LU 11-189250 DZ

Attached are the amended drawings for our previously submitted Design Review application. These documents are to serve as information for the upcoming hearing of September 6th, 2012.

BROADWAY TOYOTA

PROPOSED SITE PLAN

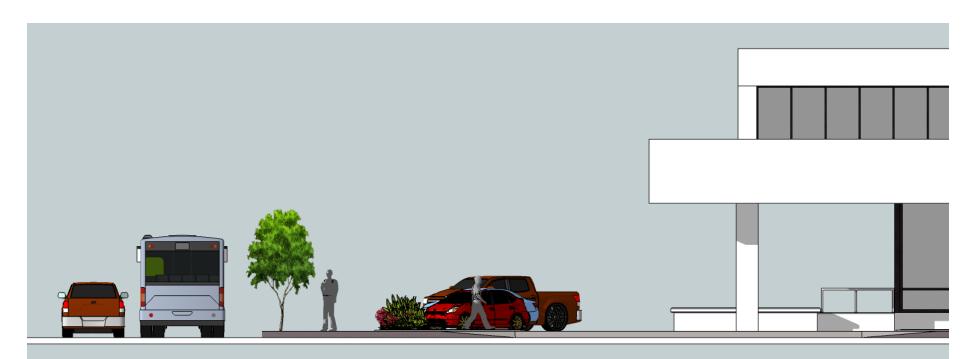
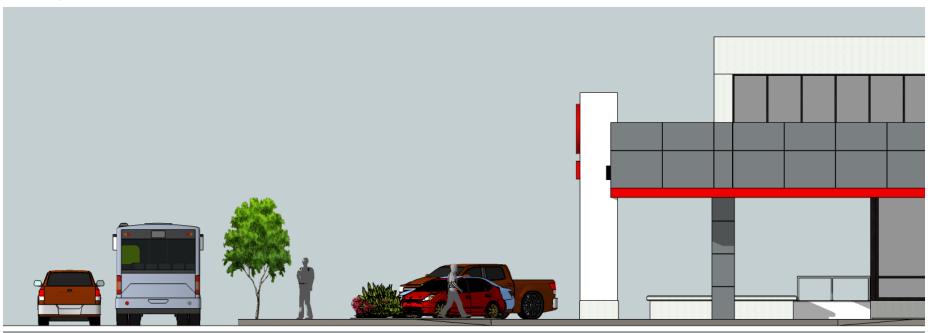
- The entry portal is now almost half the size of the original design. By reducing its dimensions, we believe it better compliments the scale of the existing structure and presents a more gentle gesture toward the pedestrian realm while still effectively marking the main entry.

- The entry portal is now symmetrical. This revision offers an entry element that is indicative of and reinforces the form of the column and lintel façade of the existing building.

- The internal illumination has been removed from the design. The entry structure will still be constructed of translucent glass and metal as previously submitted in our original application, however without the internal lighting fixtures. Instead, new down-lights are proposed in the ceiling of the "archway" to further emphasize the path of entry.

- The sign square footage on the entry element has been reduced to just 80 square feet which is below the 100 square feet allowed by the sign code. We believe this smaller sign also better fits with the overall scale of the entry portal and façade beyond.
